BEFORE THE MERIDIAN CITY COUNCIL

IN THE MATTER OF THE)
REQUEST FOR FINAL PLAT)
CONSISTING OF 10 BUILDING)
LOTS AND FOUR (4) COMMON)
LOTS ON 2.77-ACRES OF LAND IN)
THE R-8 ZONING DISTRICT FOR)
JULIA SUBDIVISION.)
BY: ACKERMAN-ESTVOLD)
APPLICANT)

CASE NO. FP-2024-0009
ORDER OF CONDITIONAL
APPROVAL OF FINAL PLAT

B. Final Plat (dated: 9/16/2024)

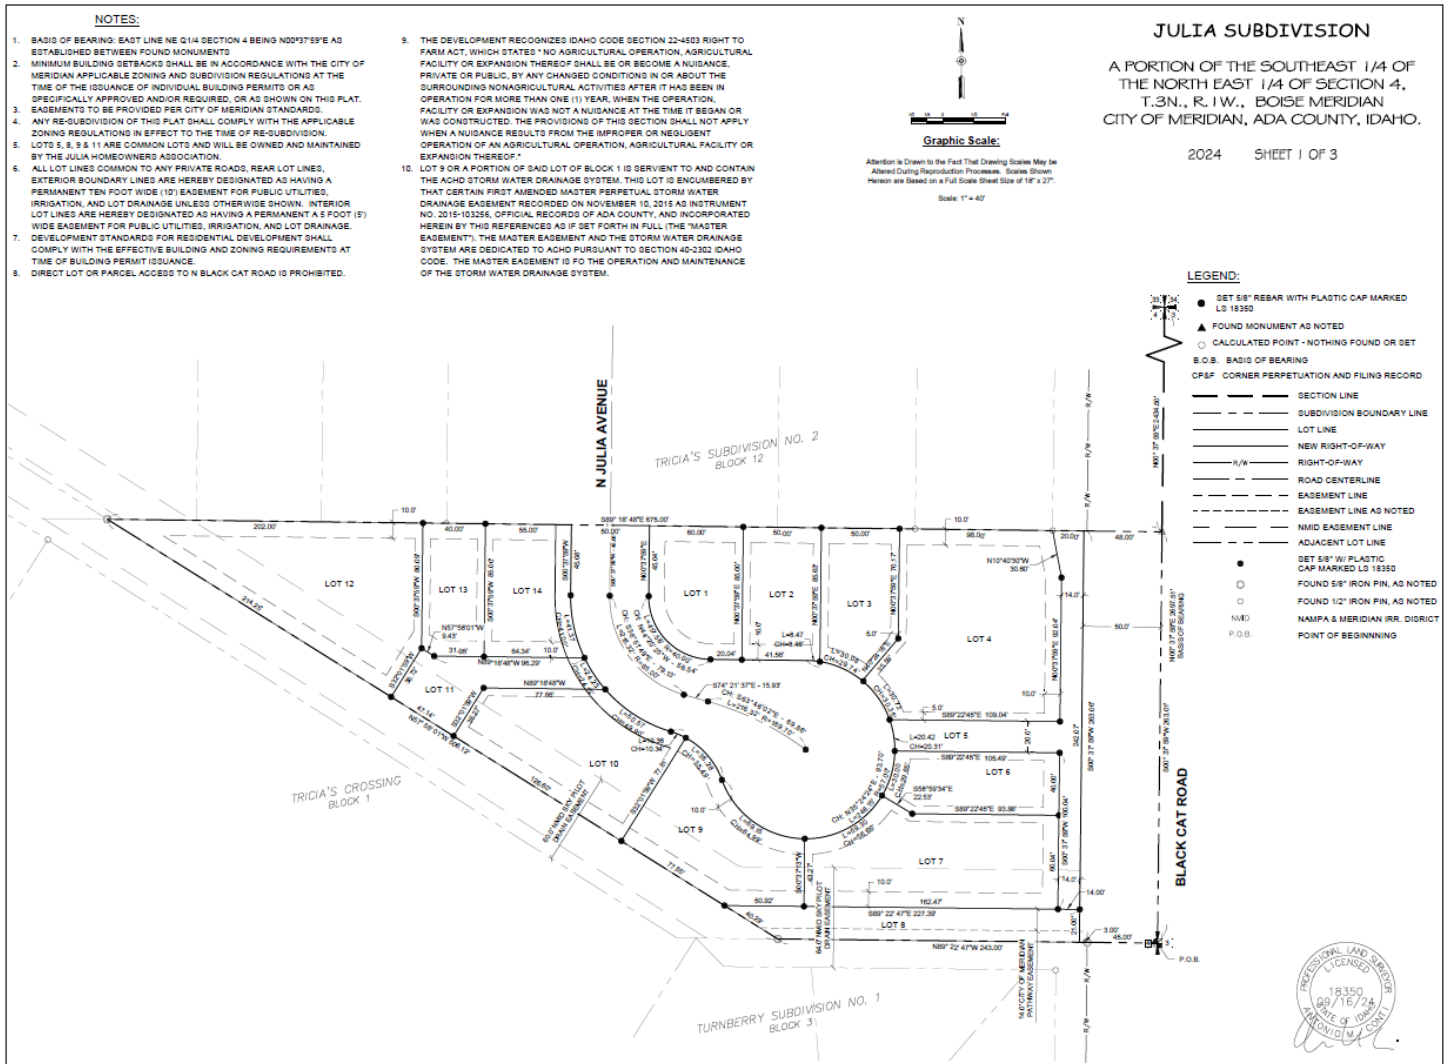
3. Prior to submittal for the City Engineer's signature, have the Certificate of Owners and the accompanying acknowledgement signed and notarized.
4. The final plat prepared by Ackerman Estvold, stamped on 9/16/24 by Antonio Conti, included in Exhibit B shall be revised as follows:

- a. If Lot 5 contains an easement, graphically depict it on the plat along with a recorded instrument number, if applicable.
 - b. Depict 30-foot minimum street frontages for Lots 3, 4 and 6, measured as a *chord* measurement, per UDC 11-2A-3B.1.

- c. Graphically depict and include a note for a perpetual ingress/egress easement for the common driveway on Lot 11 that includes a requirement for maintenance of a paved surface capable of supporting fire vehicles and equipment as set forth in UDC 11-6C-3D8; or, record a separate easement/agreement and include a reference to the recorded instrument number on the plat.

- d. Note #2: "Minimum building setbacks shall be in accordance with the City of Meridian applicable zoning and subdivision regulations at the time of issuance of individual building permits ~~or as specifically approved and/or required, or as shown on this plat.~~"

- e. Note #6: "All lot lines common to any ~~private~~ public roads, rear lot lines, exterior boundary lines are hereby designated as having a permanent ten-foot wide (10') easement for public utilities, irrigation, and lot drainage unless otherwise shown. Interior lot lines are hereby designated as having a permanent ~~a~~ 5-foot (5') wide easement for public utilities, irrigation, and lot drainage."

- f. Add a new note: "Lot 8 contains a City of Meridian pedestrian pathway easement, recorded as instrument _____."
 - g. Add a new note: "Lots 7-12 contain a Nampa Meridian Irrigation District easement for the Sky Pilot Drain." Also, include information about the anticipated license agreement with NMID, including the recorded instrument number of the agreement, and the specifics of what is and isn't allowed in the easement area.

- h. Depict a 5-foot wide detached sidewalk along N. Black Cat Rd. as requested by ACHD and agreed up by Planning Staff to match the width of the existing sidewalk to the north & south.

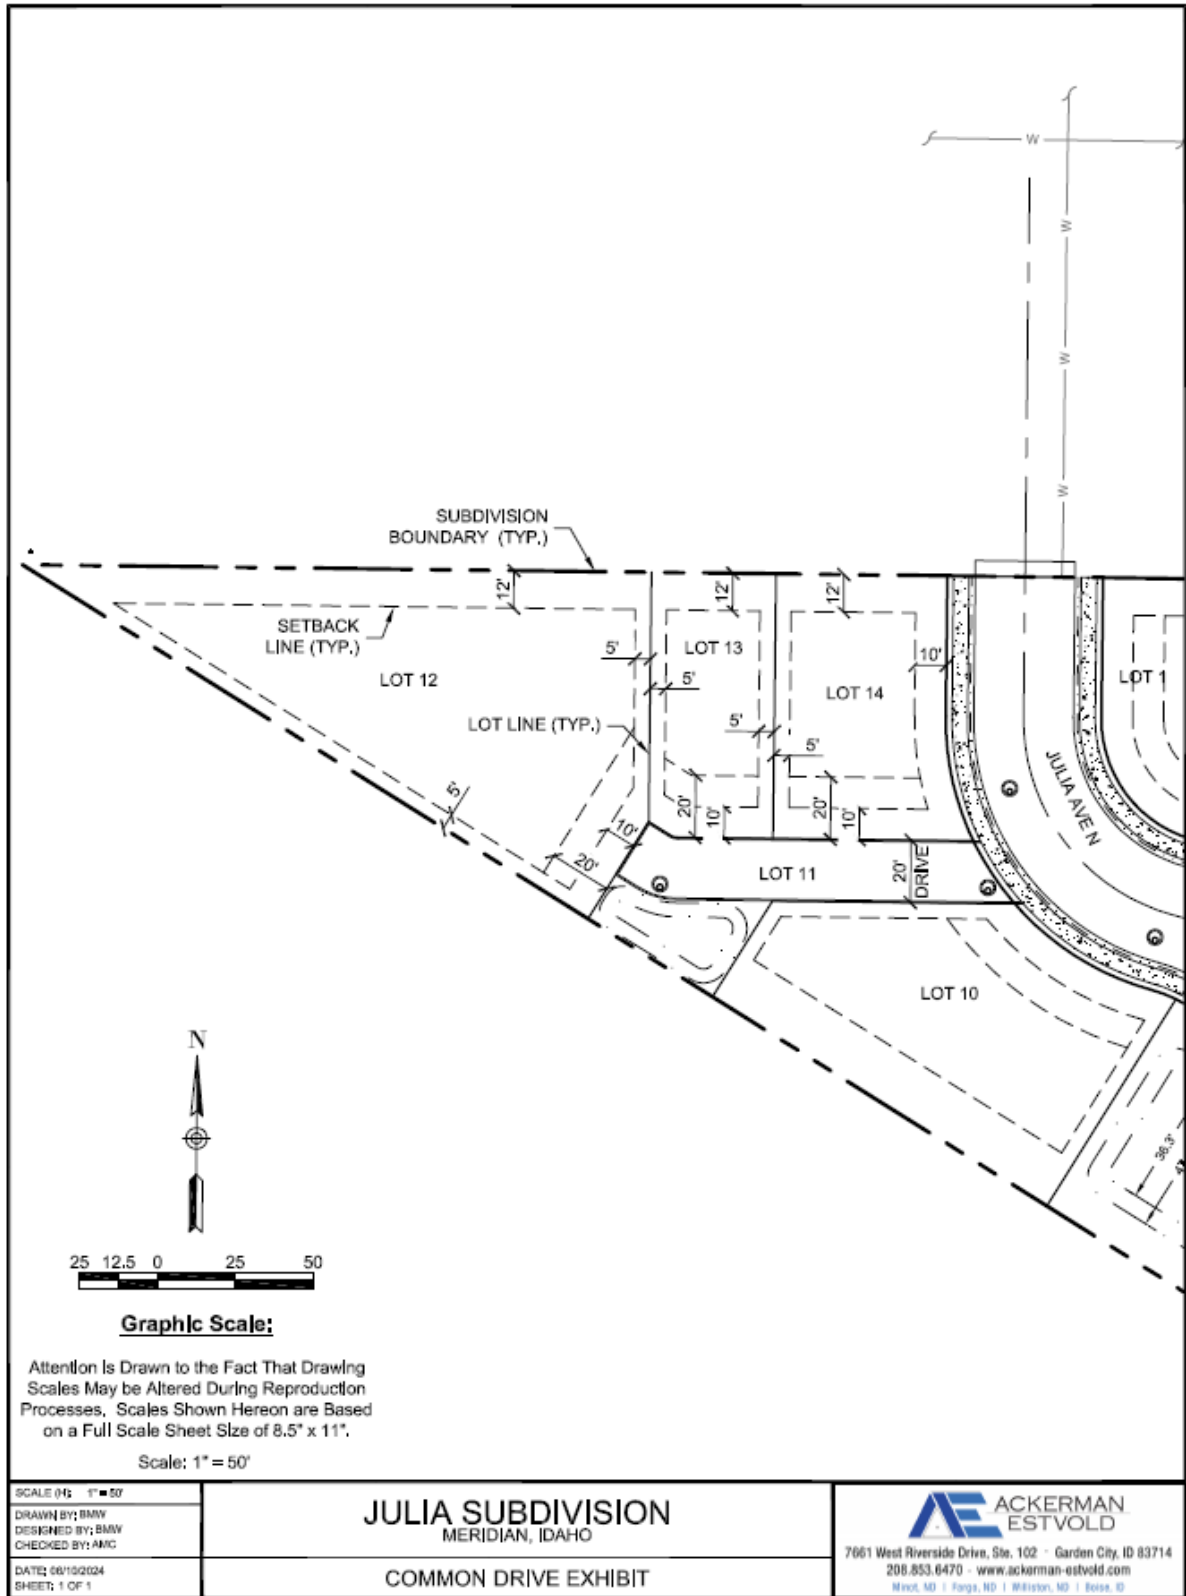
- c. Change the fencing type along the western boundary of the site adjacent to the common open space in Tricia's Crossing subdivision to open vision or semi-private up to 6-feet in height or if closed vision fencing is proposed, it can't exceed 4-feet in height, as set forth in UDC 11-3A-7A.7b.
